PROJECT: 23-26- Sequoyah Bus Parking
Bid Date 3-28-2023 at 3pm

PROJECT NO. 21330

Narrative For Addendum #1

DATE: 3-21-2023

C200
 EXISTING CONDITIONS
 AND DEMOLITION
 PLAN

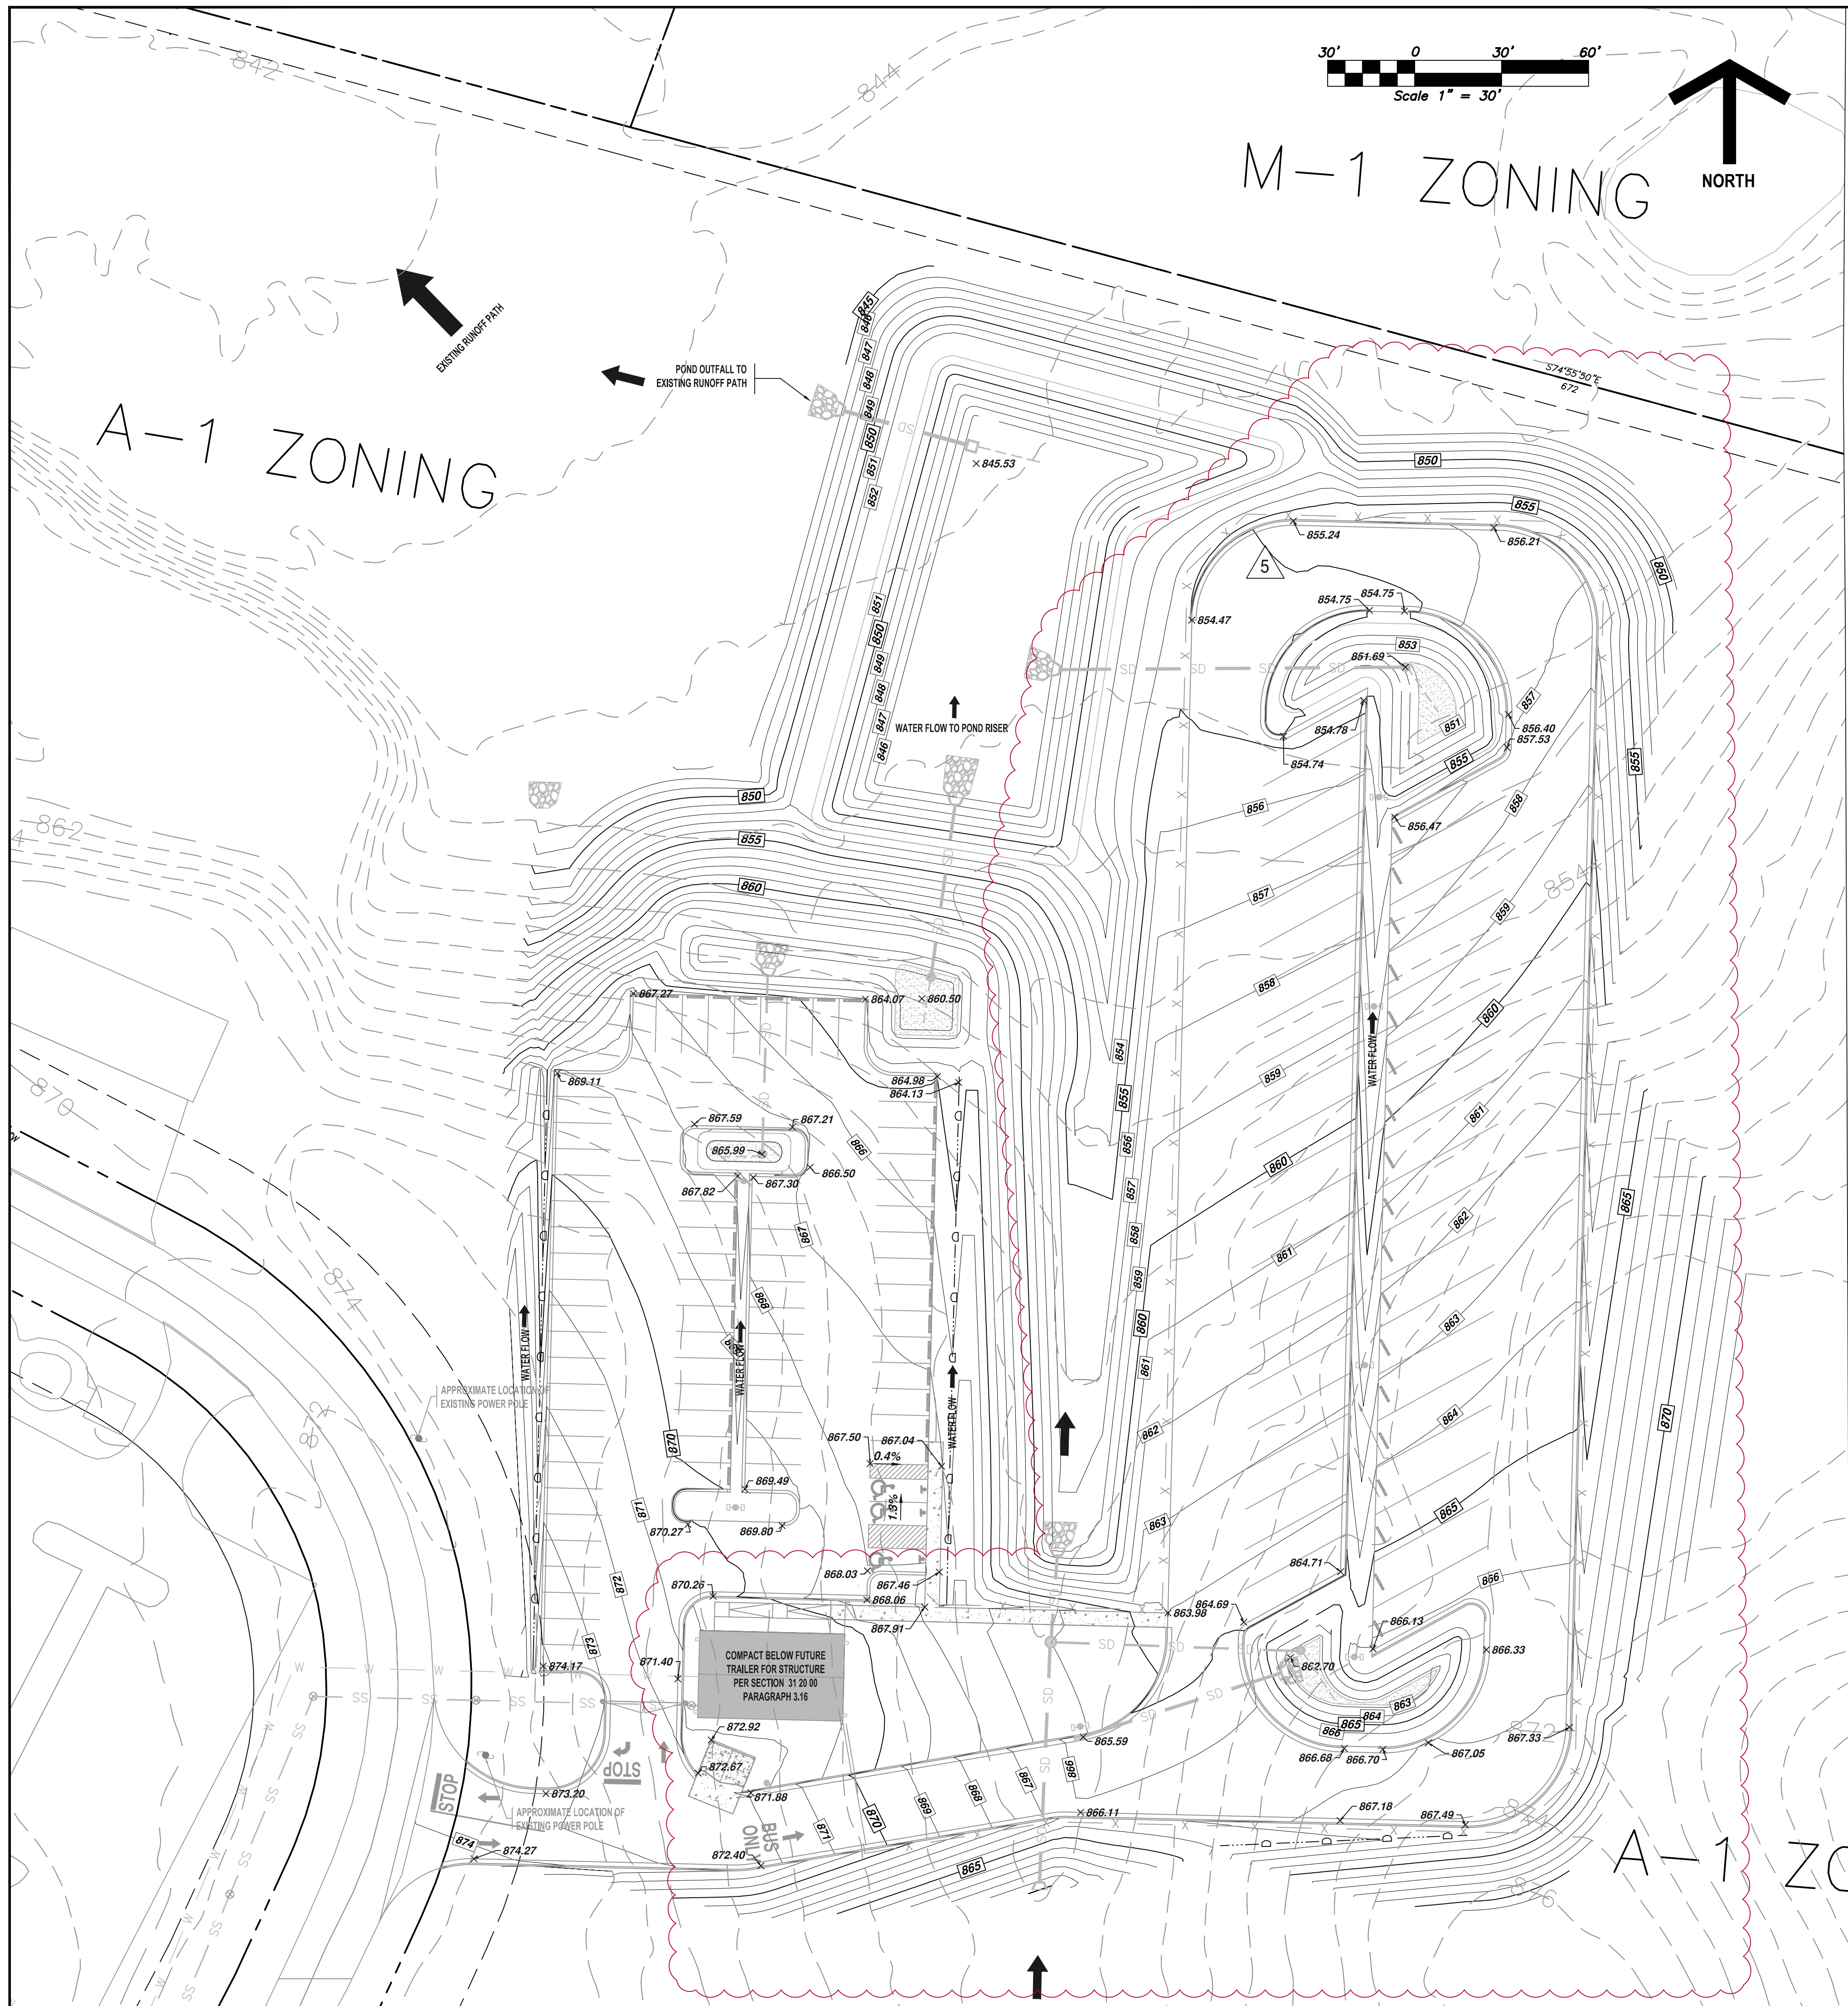
5. Added note regarding relocation of ROTC equipment.

C301

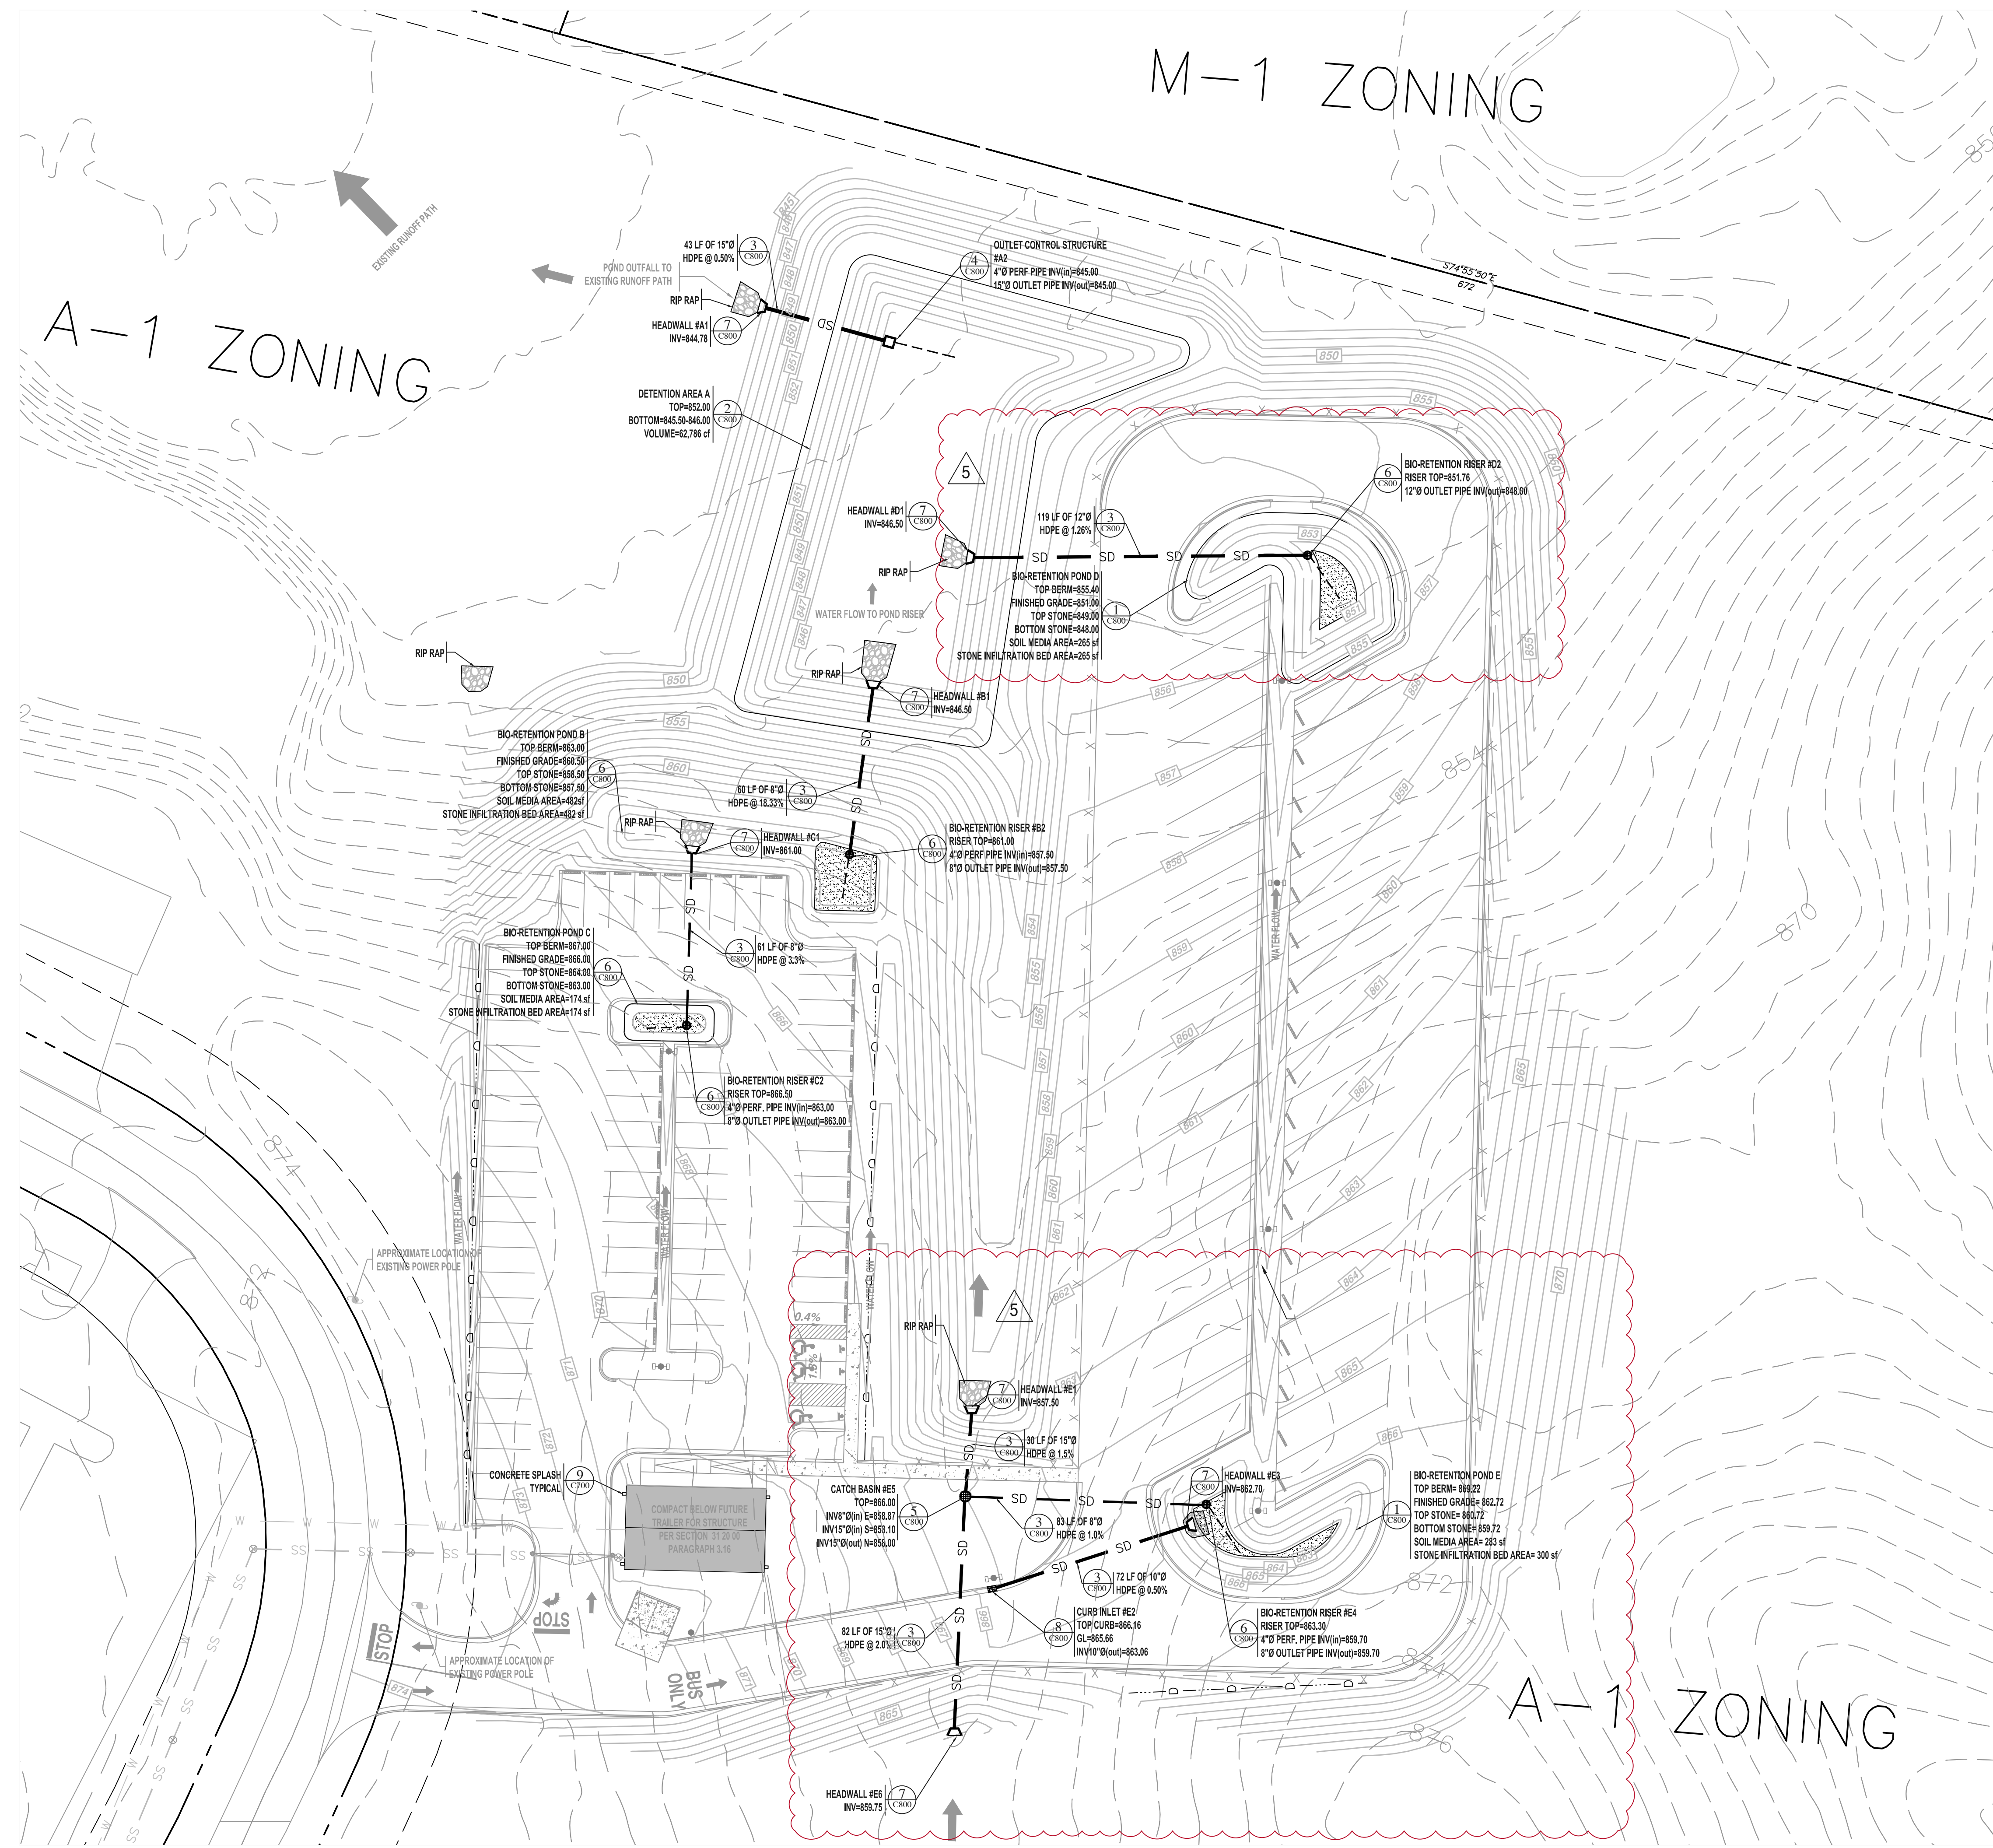
1. Lowered proposed grade of bus parking lot 3-ft to reduce volume of haul in.

SITE DRAINAGE PLAN

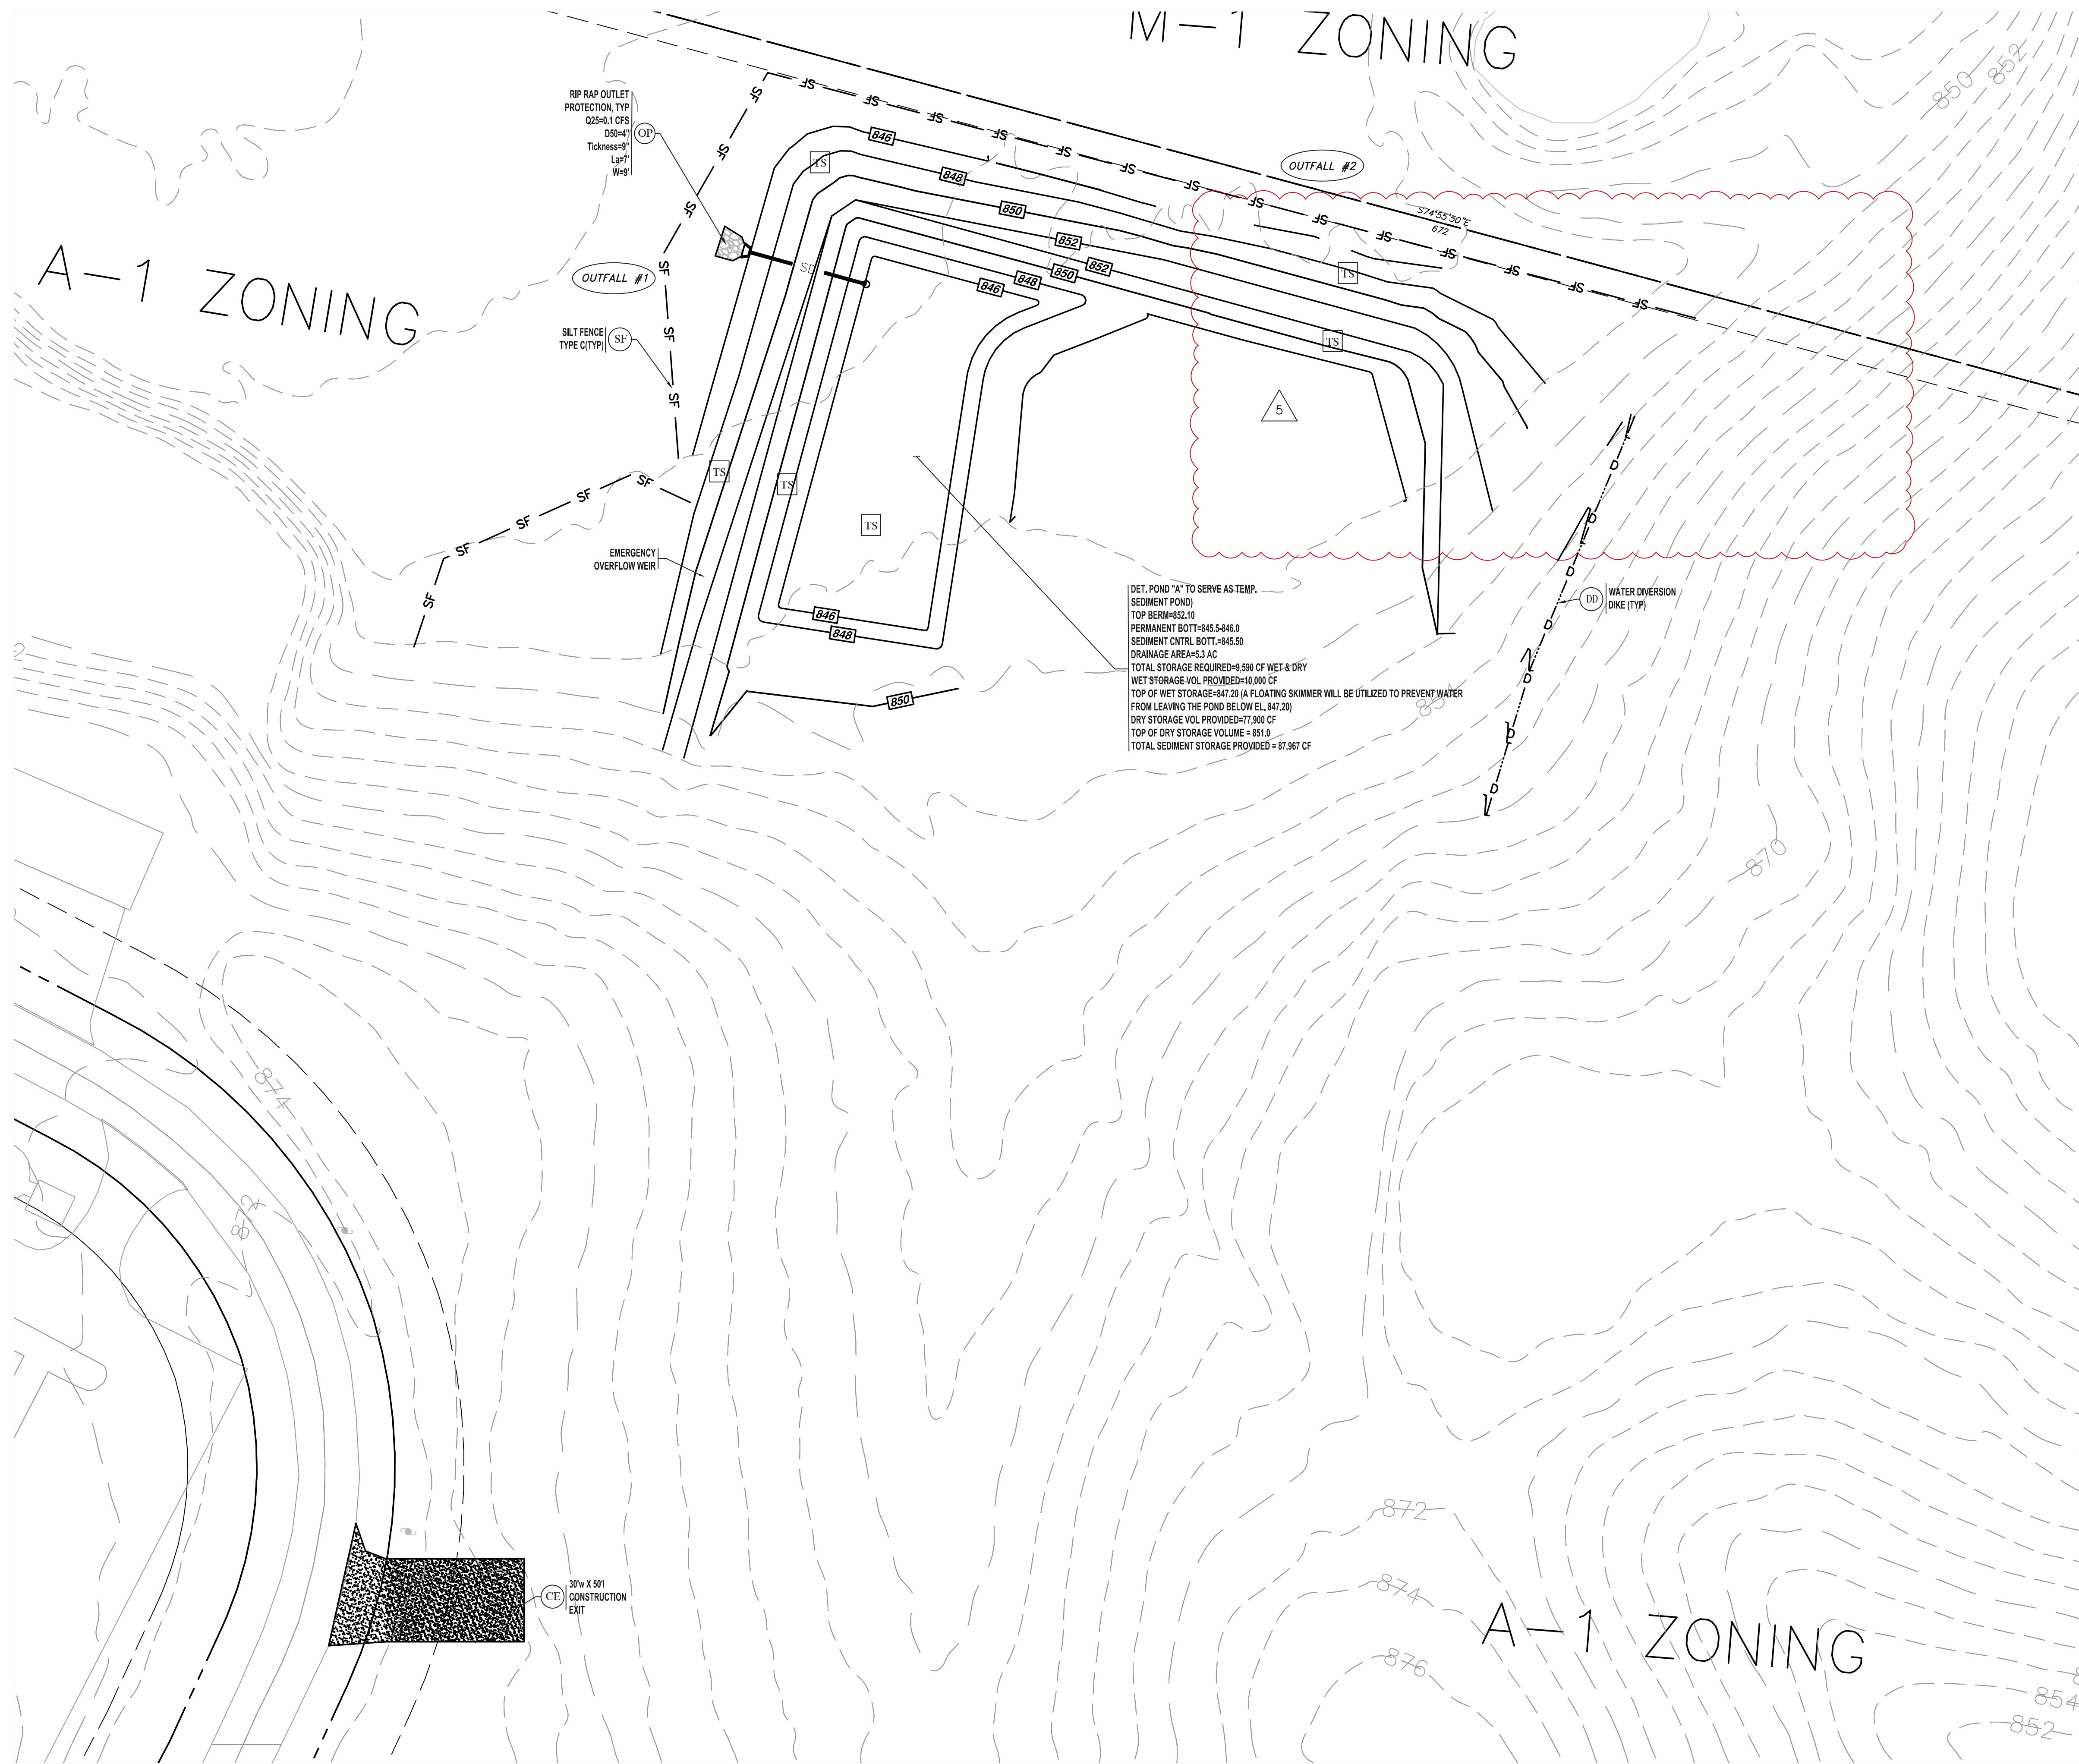
1. Adjust drainage pipes and structure in or near bus parking based on revised grading.
2. Revised diameter of drainage culvert E1-E6 from 12" to 15" and reduced its length.
3. Revised diameter of E2 to E3 from 12" to 10".
4. Added underdrain in bio-retention Pond E connecting to Riser E4
